Common Structural Rules for Bulk Carriers, January 2006

Rule Change Notice 3 **(Ch 8 Sec 2, 2.3 Equivalent notch stress range)**

Technical Background for Rule Change Notice 3 (Ch 8 Sec 2, 2.3 Equivalent notch stress range)

Fig. 3.1 Hot spot stress range and hot spot mean stress

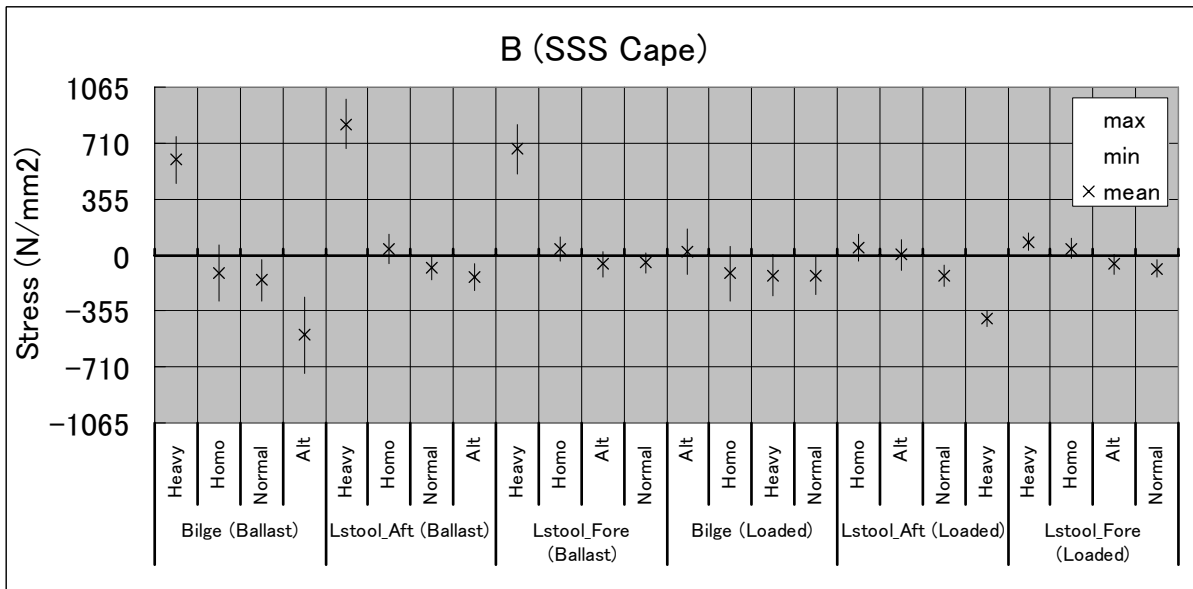
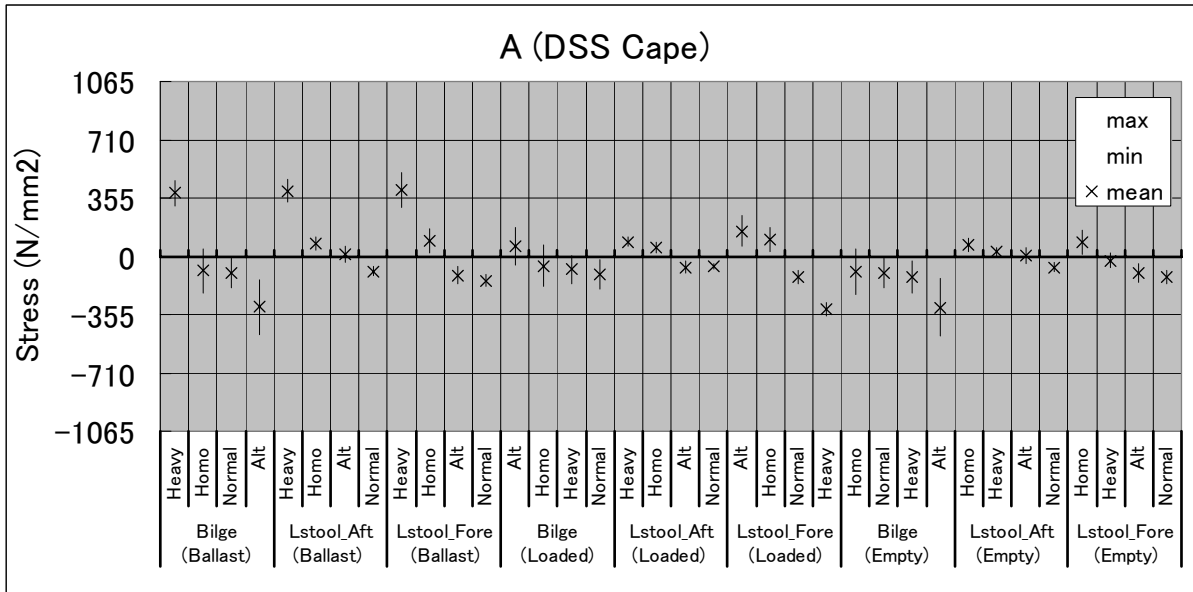
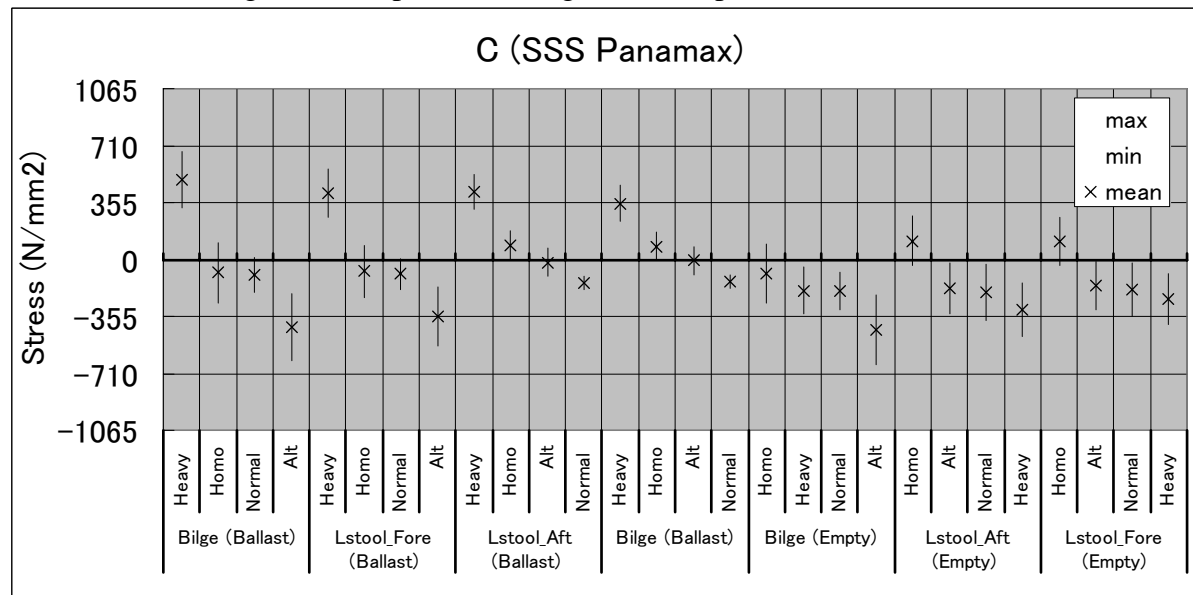
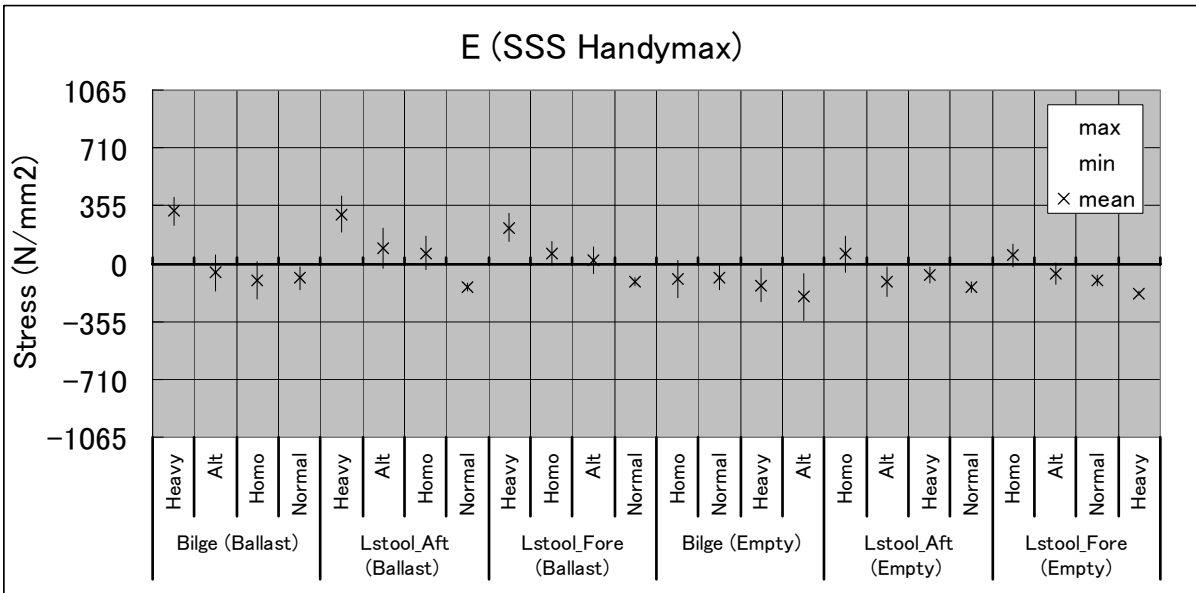
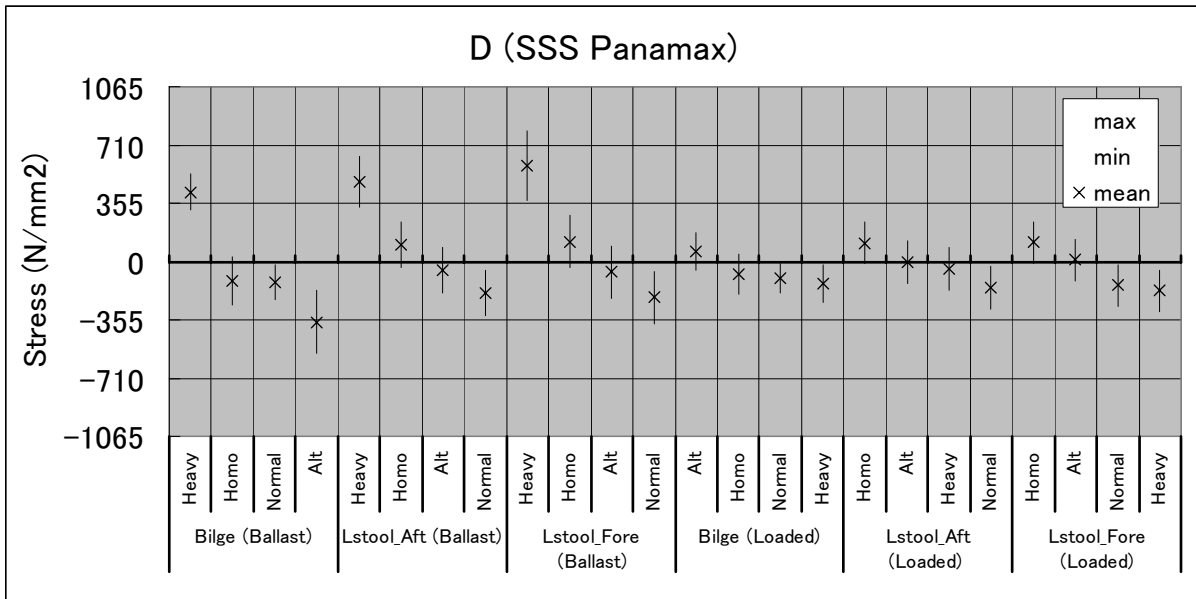
The equivalent hot spot stress range and mean stress obtained by FEA are shown in Figure 3.1. The following cumulative fatigue damage was calculated from the above equivalent hot spot stress range and mean stress.

- (1) There is no effect on the cumulative fatigue damage at the fatigue assessment points in ballast holds where there was high tensional mean stress.
- (2) In cargo holds other than ballast holds, the cumulative fatigue damage at the fatigue assessment points was less than that of the current CSR, when there was compressive or low tensional mean stress and the hot spot stress range was large.
- (3) The relative tendency of the cumulative fatigue damage at the fatigue assessment points in ballast holds and other holds was consistent with the damage record specified in the Appendix.
- (4) The cumulative fatigue damage with grinding was about 60% of that without grinding.

Fig. 3.2 Cumulative fatigue damage

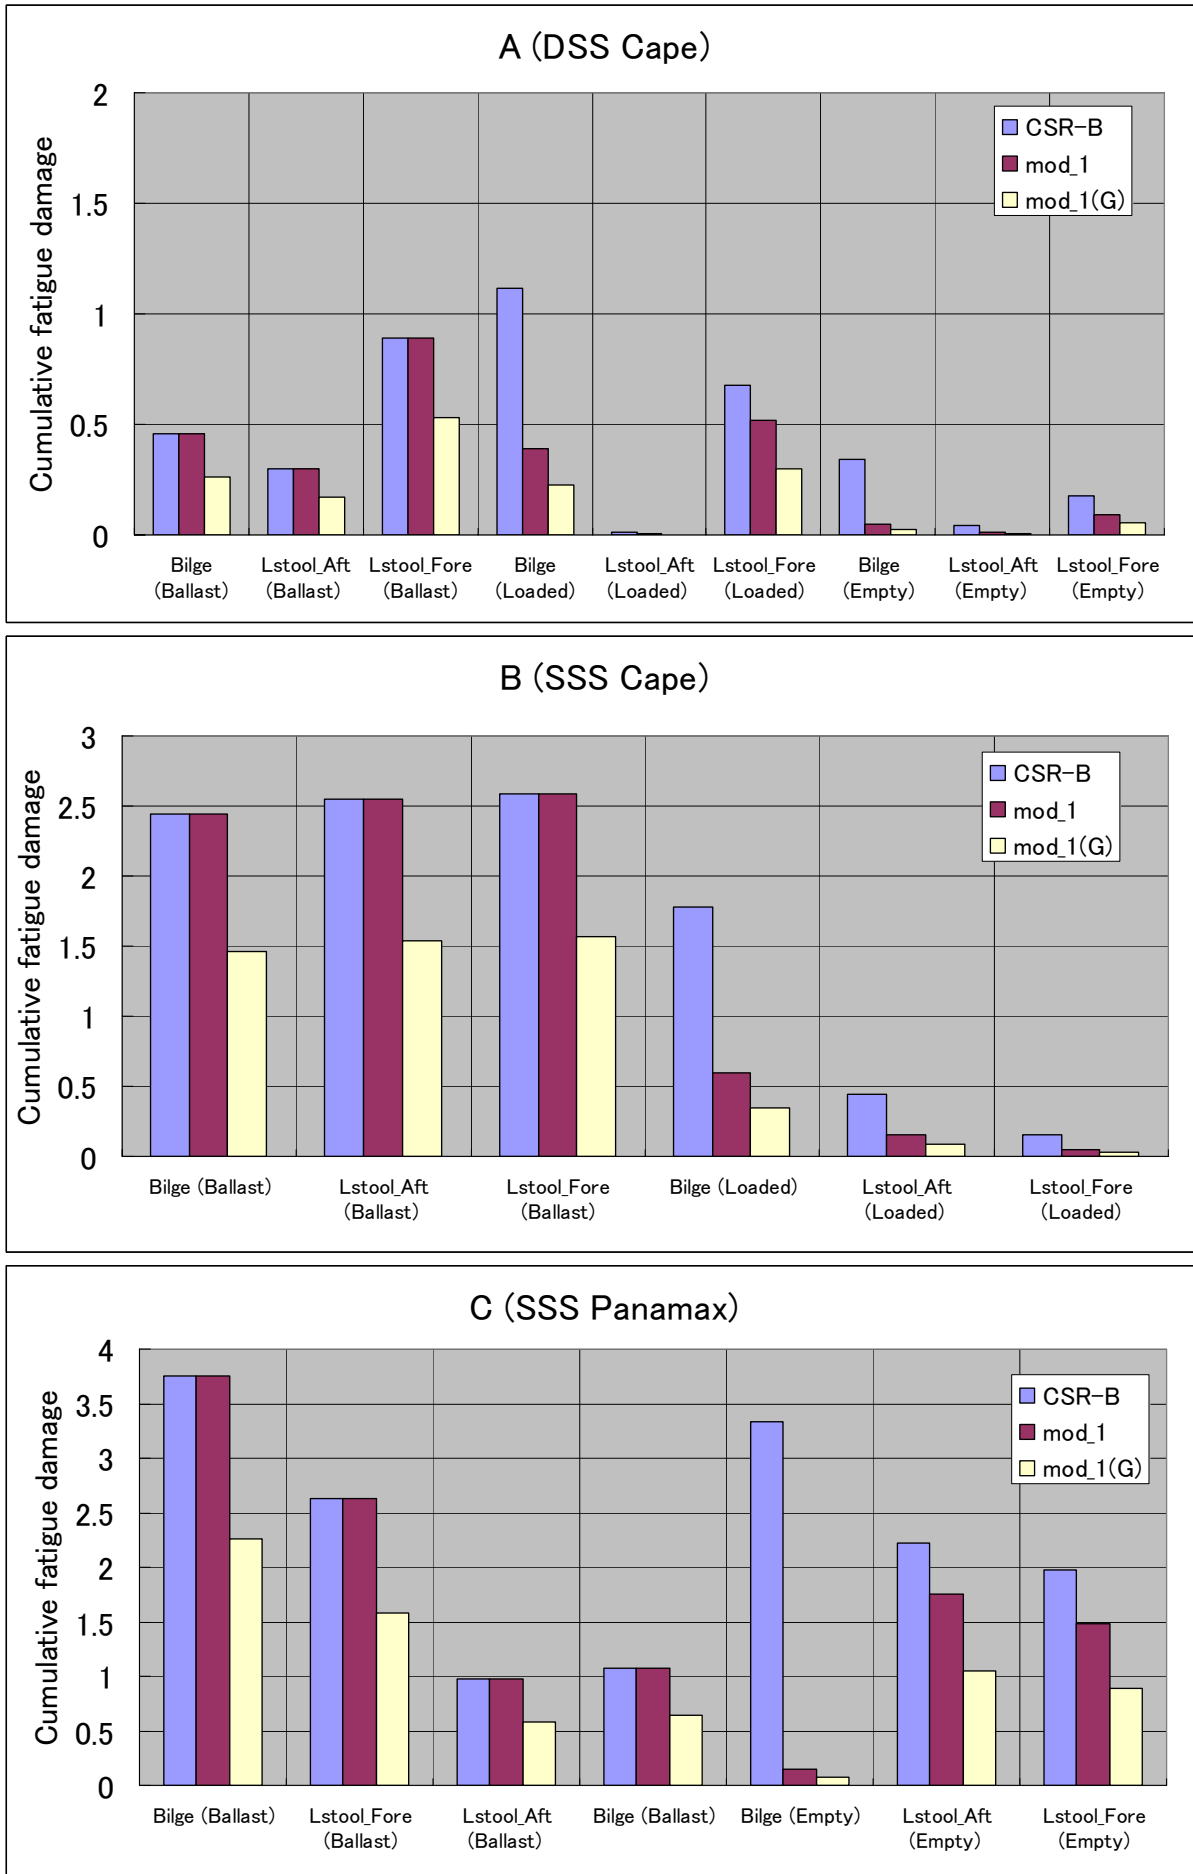
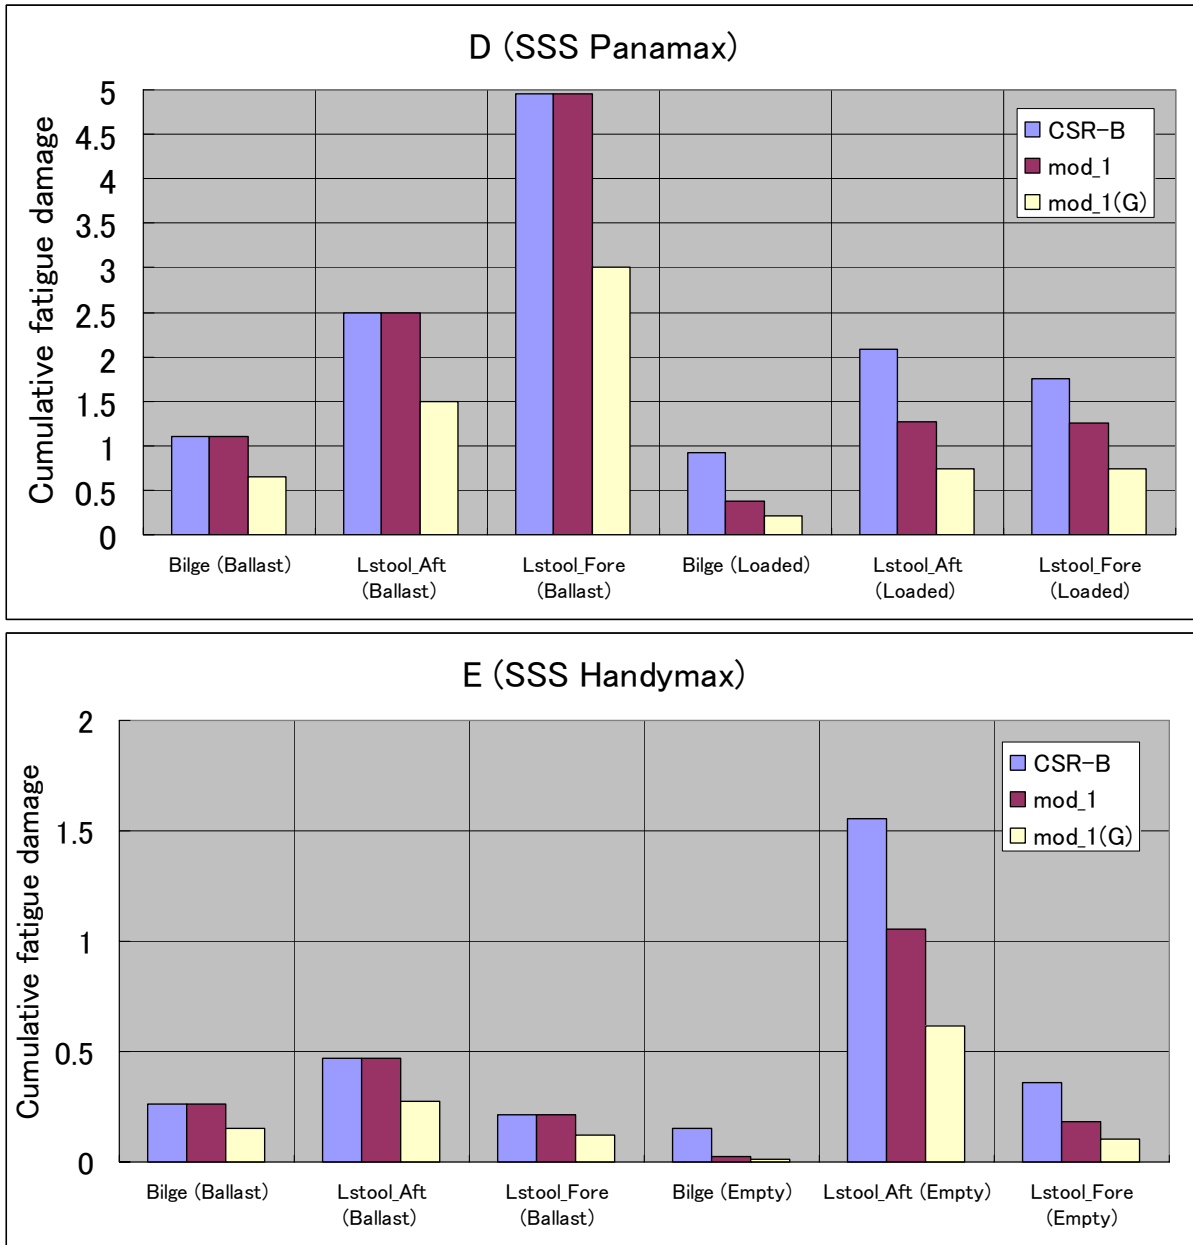
- (1) The cumulative fatigue damage according to the current CSR
- (2)(a) The cumulative fatigue damage according to the corrected formulae in 2.1 (“mod_1” in Figure 3.2)
- (b) The cumulative fatigue damage according to the corrected formulae in 2.1 with the effect of grinding in 2.2 (“mod_1(G) in Figure 3.2)

The results of the cumulative fatigue damage are shown in Figure 3.2.

From the results in Figure 3.2, the following can be said about the corrected formulae in 2.1.

Fig. A1 Illustration of the relationship of σ_{res} , σ_{mean} and σ_S

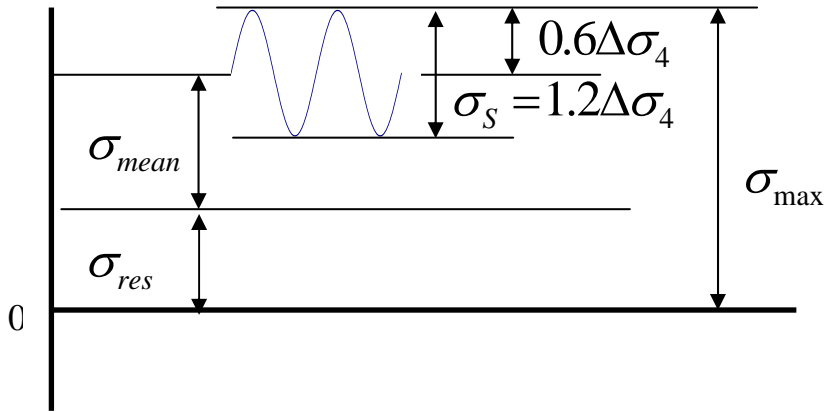
The model regarding initial residual stresses σ_{res} , mean stresses σ_{mean} and σ_s can be illustrated as given in Fig. A1 and σ_{max} is used, in order to evaluate any shake-down effects.

From the relationship illustrated by the above figure, we can get the following equation:

$$\sigma_{max} = \sigma_{res} + \sigma_{mean} + 0.5\sigma_s = \sigma_{res} + \sigma_{mean} + 0.6\Delta\sigma_4$$
